## Report to Sydney West Central Planning Panel

<b>SWCCP reference</b>	2016SYW224
<b>DA No.</b>	1005/2016
<b>Date of receipt</b>	21 October 2016
<b>Proposal</b>	Construction of a mixed use development of 3 buildings with heights of 4 - 14 storeys containing 421 residential units, 6 neighbourhood shops over 2 levels of basement car parking, and subdivision to create 3 development lots and 1 road lot to be dedicated to council.
<b>Street address</b>	29 Carter Street, Lidcombe
<b>Property Description</b>	Lot 13 DP 1217641
<b>Applicant</b>	Australia YMCI PTY LTD
<b>Owner</b>	Australia YMCI PTY LTD
<b>Submissions</b>	One
<b>List of All Relevant s79C(1)(a) Matters</b>	<ul style="list-style-type: none"><li>• Environmental Planning and Assessment Act and Regulations</li><li>• State Environmental Planning Policy No. 55</li><li>• State Environmental Planning Policy No. 65 (Design Quality of Residential Apartment Development)</li><li>• State Environmental Planning Policy (Sydney Harbour Catchment) 2005</li><li>• State Environmental Planning Policy (Building Sustainability Index: BASIX)</li><li>• State Environmental Planning Policy (State and Regional Development) 2011</li><li>• Auburn Local

Figure 3: Massing distribution diagram showing areas of increased / decreased heights relative to LEP controls

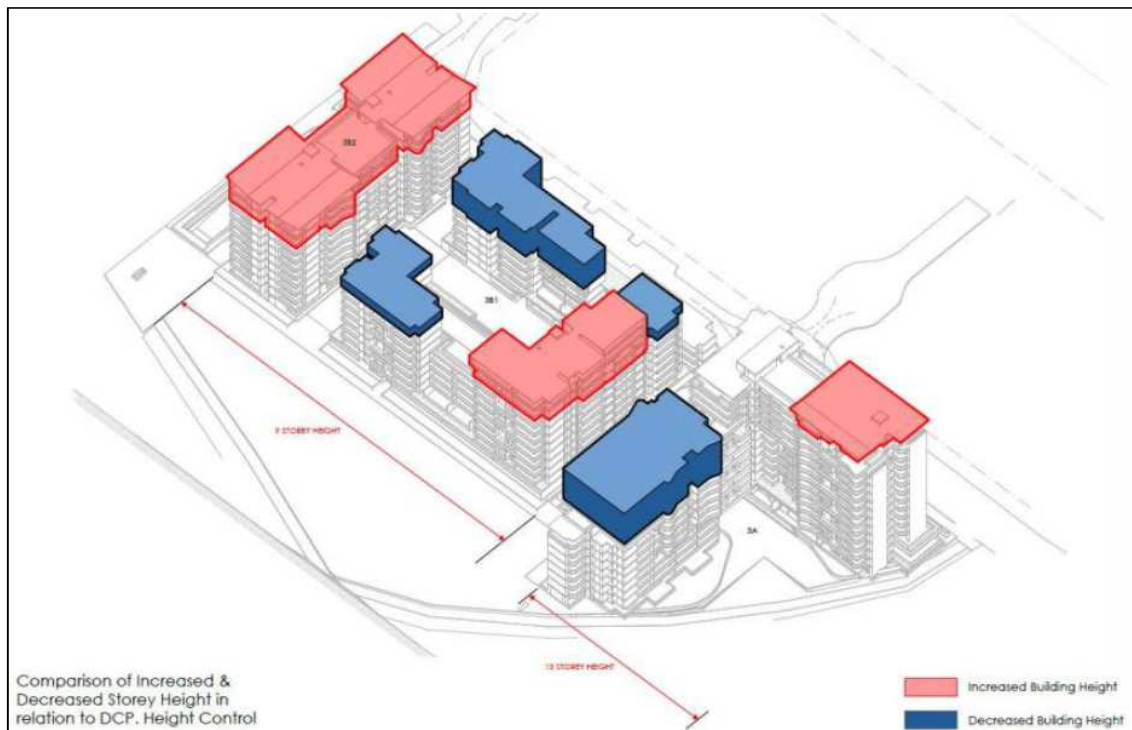
- Building 3A - 48.58m (Non-compliance is 6.58m or 13.5%)
- Building 3B1 - 38.95m (Non-compliance is 9.05m or 23.2%)
- Building 3B2 - 38.65m (Non-compliance is 8.75m or 22.6%)

Figure 4: Location of additional laneway shown in red

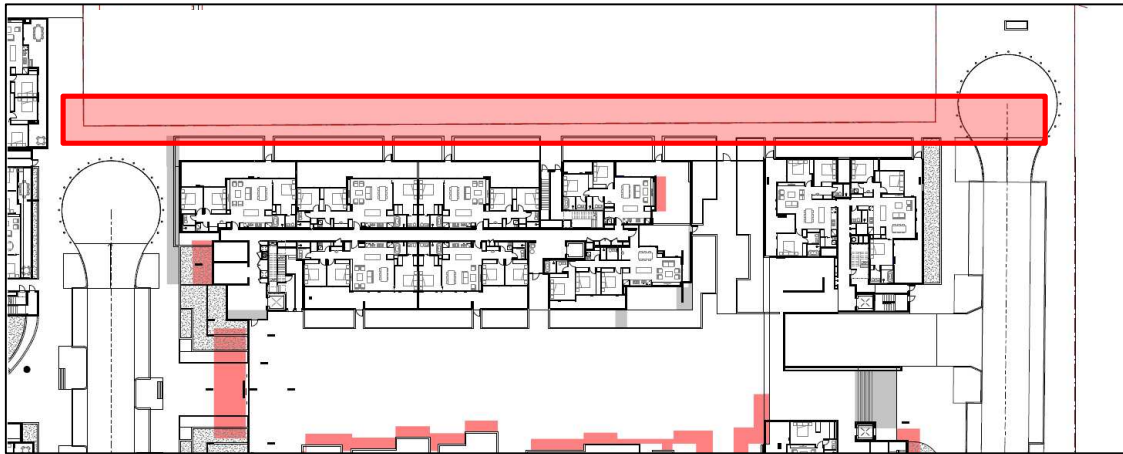
The applicant is reluctant to revise its design for this purpose, as such would require the removal of the generous planter boxes at the ground level edge of building 3B1. The location of the zone boundary between the R4 land and adjacent RE1 land, which will define the boundary between future public/private land, is also a constraint. However, Council is firm in its position that this road is warranted. The solution recommended by this report is therefore as follows:

Provision of this laneway will require amendments to the public domain elements of the scheme, and is therefore addressed by means of a deferred commencement condition. Further, as the roads are outside the scope of this DA, a condition is also required linking this application to DA 1089/2016 to ensure consistency between those two approvals.

- The ground floor planter boxes adjacent to the northern edge of building 3B1 to be reduced to a maximum width of 3.2m, to allow for a 1.8m footpath that will abut the boundary of the RE1 zoned land; and
- A laneway (3m wide) will be located wholly within land zoned RE1. It will be constructed by the applicant and dedicated to council.

Figure 5: DCP street network

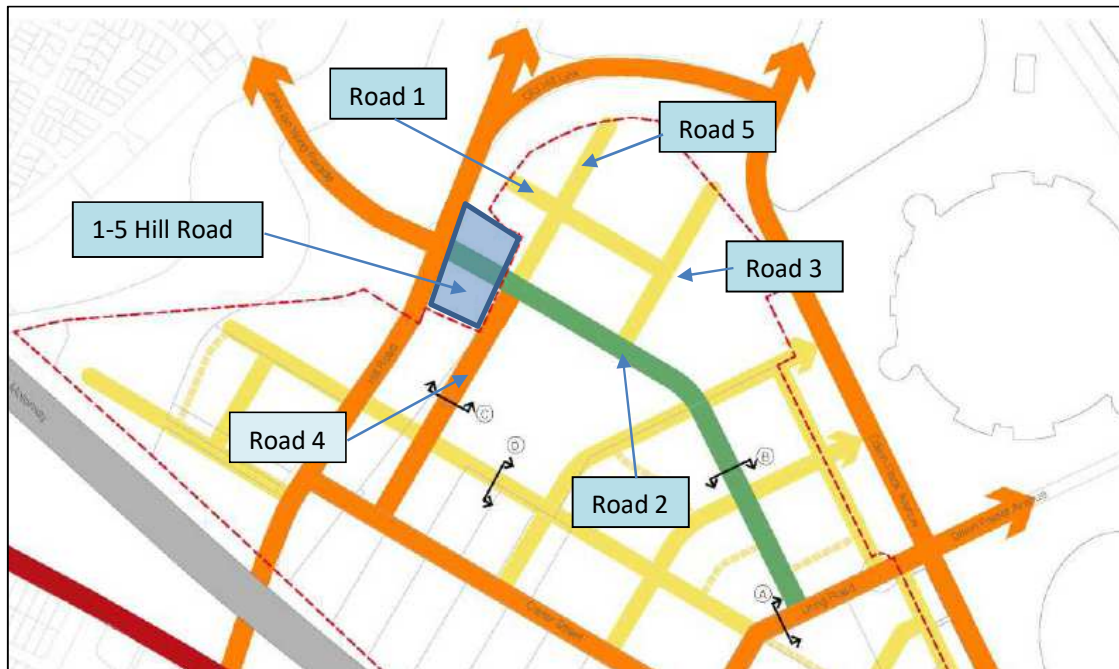
*The alignment of the north south road being the road between building 3A and 3B1 is identified as a local road. Its alignment further south abuts No.1-5 Hill Road. The diagram at Figure 3 (of the Carter Street Development Control Plan) suggests that there will be a road frontage contemplated for the south eastern boundary of my client's property.*

*The plan and setout of the road being proposed as part of this application would appear to be setback when extrapolated some 10-20 metres from the south/east portion of my client's site. It would appear that the alignment has been moved east. Furthermore, the indicative alignment of the east/west road which is to link with Wing Parade also appears to be slightly north of the alignment.*

*We object to the current proposal because it is not consistent with Figure 3 Street Network and should be amended to show that the extension of the north/south road between Buildings 3A and 3B1 will deliver the same conditions as envisaged in the Carter Street Precinct DCP 2016, being a road frontage (to Nos 1-5 Hill Road). Furthermore, all east/west roads should reflect the DCP.*

- The scope of DA 1089/2016 (and by necessity, this current DA) does not include any roads south of Road 2.
- The street network nominated under DA 1089/2016 (Roads 1 and 3 and part of Road 5) is generally consistent with the DCP. Nevertheless, it is correct that the alignment of some of those roads does vary from the DCP, as follows:

- On the architectural plans Road 2 is north of the nominated location, though the civil plans for DA 1089/2016 appear correct.
  - The location of Road 5 between block 3A and 3B1 is east of the DCP position.
